BCA Design Assessment Report

19 Sydney Road, Manly

Project: 19 Sydney Road, Manly
 Document Type: BCA Design Assessment Report
 Report Number: P221_387-01 (BCA) JR

Figure C1.1(b) - Skylights within 3m Range of the Side Boundary

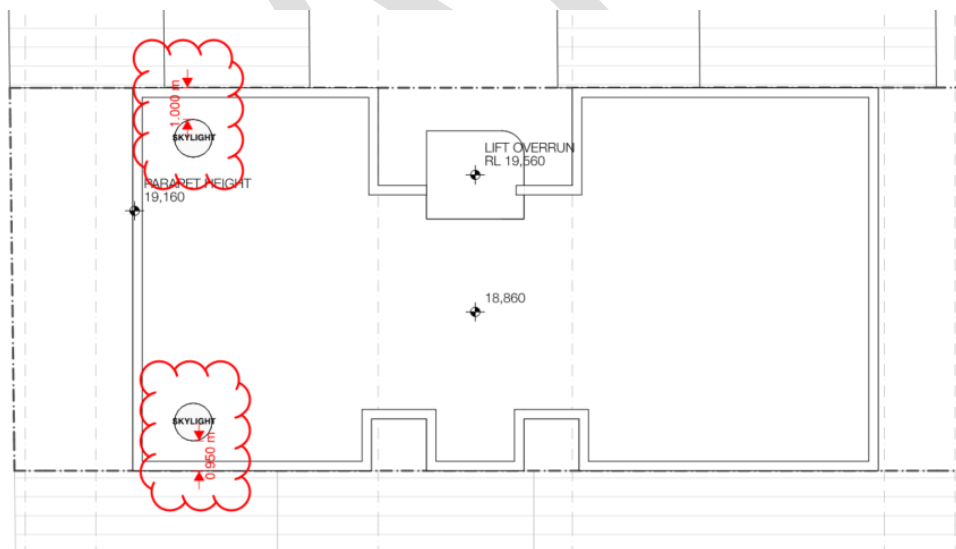
An assessment of the drawings shows that there are two skylights located within 3m of a fire source feature, being the side boundary. Therefore, the following design options are available to achieve compliance with the BCA –

- (i) Option 1 – Reconfigure the existing layout and relocate the roof lights so that they are not located within a 3m proximity to the side boundary; or
- (ii) Option 2 – Justify exposed skylights within 3m of a side boundary under a performance-based design.

Figure C2.6 – Southern Elevation Perspective

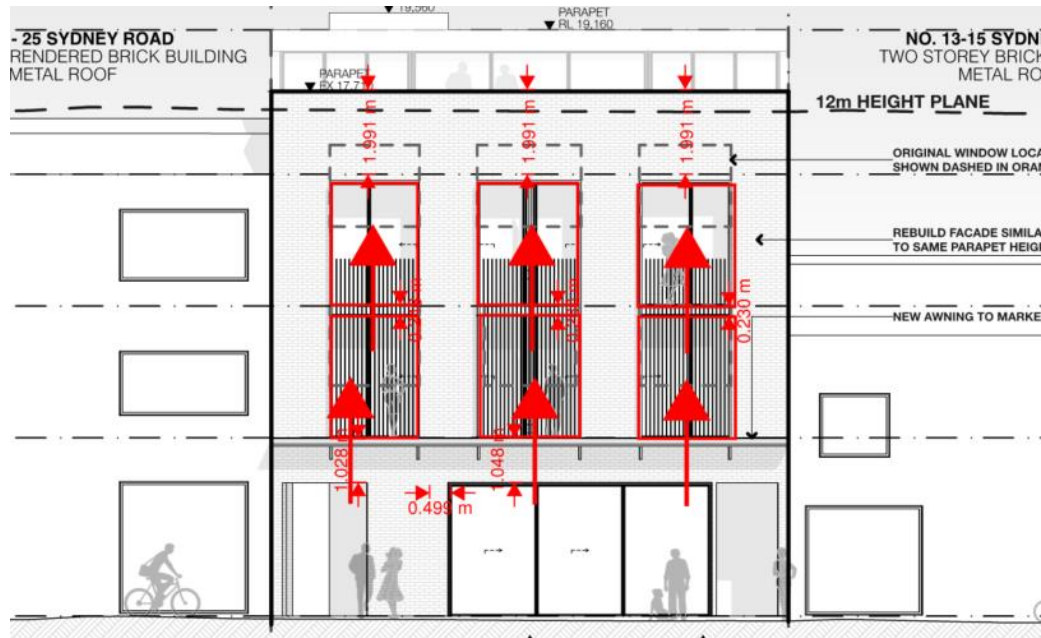
An assessment of the proposed development shows that separation is not achieve to the following areas –

Southern Façade

- The provision of spandrels within the external walls not less than 900mm in height and extend not less than 600mm above the finished floor level. The spandrels are required to be non-combustible and have an FRL being not less than 60/60/60; or
- The provision of horizontal aprons/projections that project outwards from the external face of the wall not less than 1100mm beyond the affected openings and extend not less than 450mm (taken as being the most forward projecting openings). The horizontal projections are required to be non-combustible and have an FRL being not less than 60/60/60).

Figure C3.2(a) – Ground level exposed openings

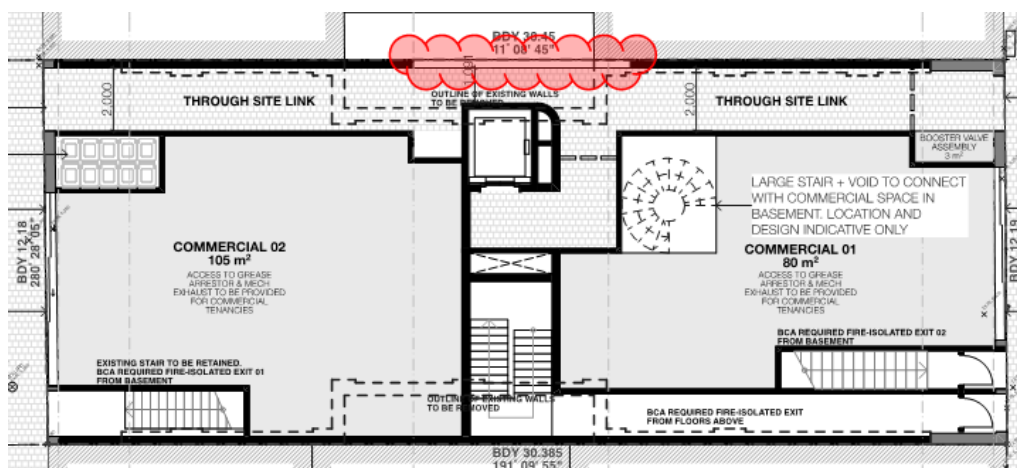
Based off our assessment, numerous openings are located within range of fire source features. These openings will require protection in accordance with C3.4, or there may be scope to assess under the performance provisions of the BCA via a fire engineered performance solution.

- (i) Openings within 3m of the side / rear boundary; and
 - East Elevation – Multiple openings are located within 3m
 - West Elevation – Multiple openings are located within 3m
- (ii) Openings within 6m of the far boundary of the road; and
 - Sydney Road – Greater than 6m
 - Market Place – Greater than 6m

Figure D1.2 – Egress within the basement storey

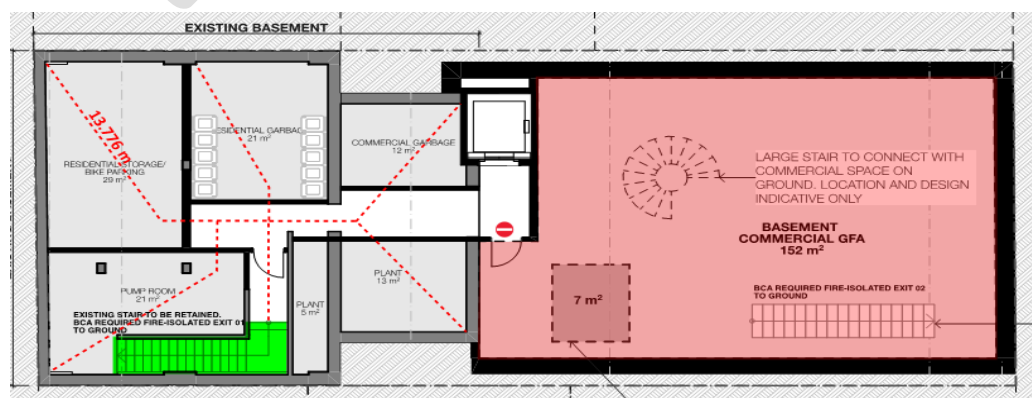
- D1.2** An assessment of the floor plans shows that parts of the basement storey will not have access to two exit where egress does not necessitate passing through another sole occupancy unit. It is recommended that the proposed layout is reviewed and justified under a performance-based design from the projects fire engineer.

Figure D1.6 – Reduced egress width caused by accessible lift

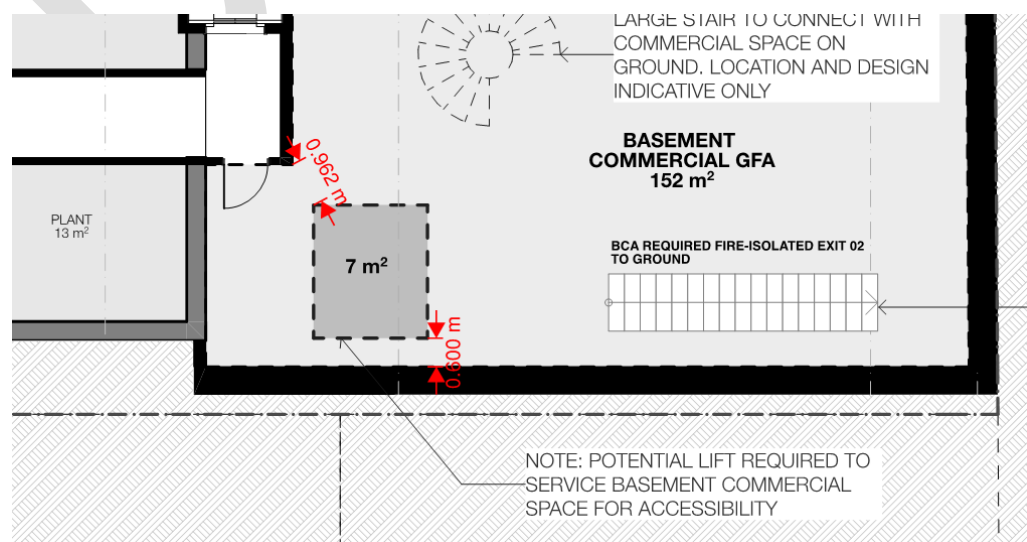
As assessment of the floor layout shows that there is an egress shortfall caused by the proposed accessible lift to the basement. With a slight re-adjustment to the design, compliance can be readily achieved.

Figure E1.3(a) – Pumproom doorway does not open directly into an exit

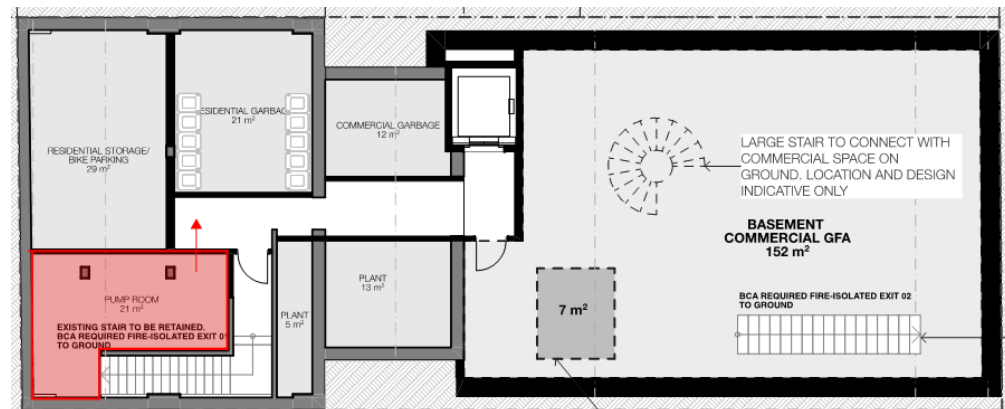
An assessment shows that the booster assembly and pumproom will be located within areas of the building which may impede on brigade invention. It is recommended that the projects fire engineer reviews and justifies the following under a performance based design –

Justify the basement pumproom not opening directly into open space or a fire isolated exit.

Figure E1.3(b) – Hydrant booster is not permitted to be located within the building

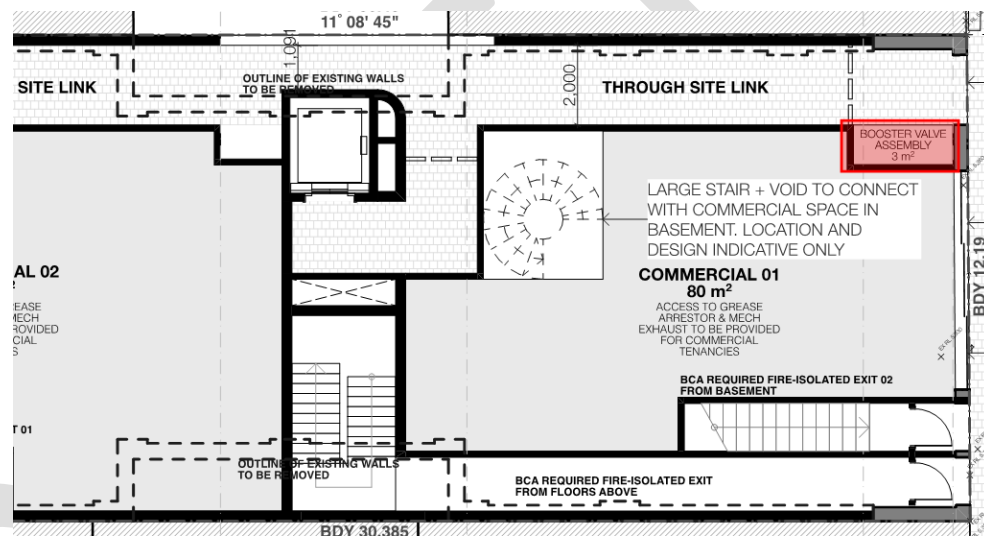
- Located within 10m of the building and not protected in accordance with subclause 7.3(c)(ii) of AS2419.1-2005; and
- Provided as an 'I' Pattern

Figure F3.1 – Head height concerns within the fire stairway

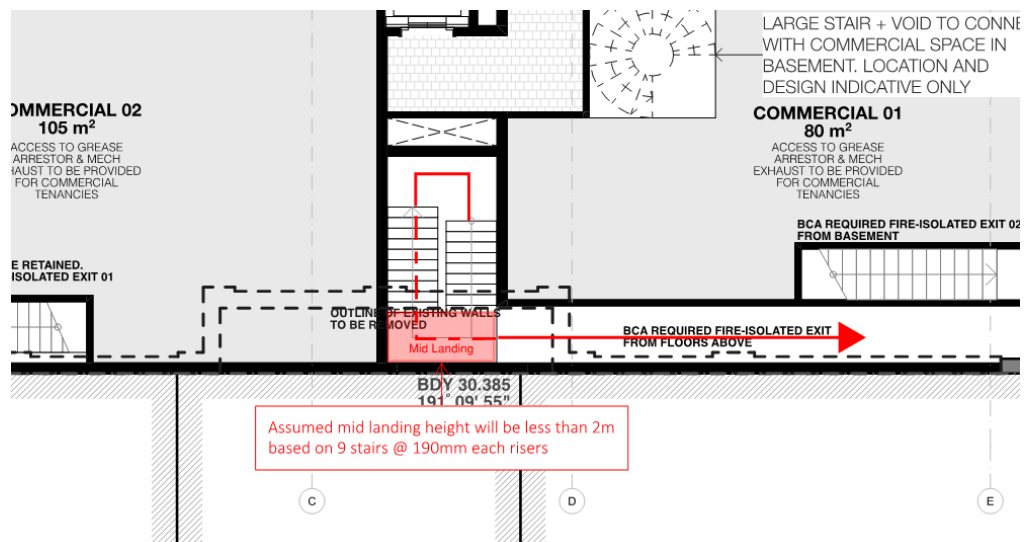
Concerns are raised that the proposed fire stairway configuration will incur head height concerns. Hence, it is requested that further architectural documentation is provided demonstrating compliance.
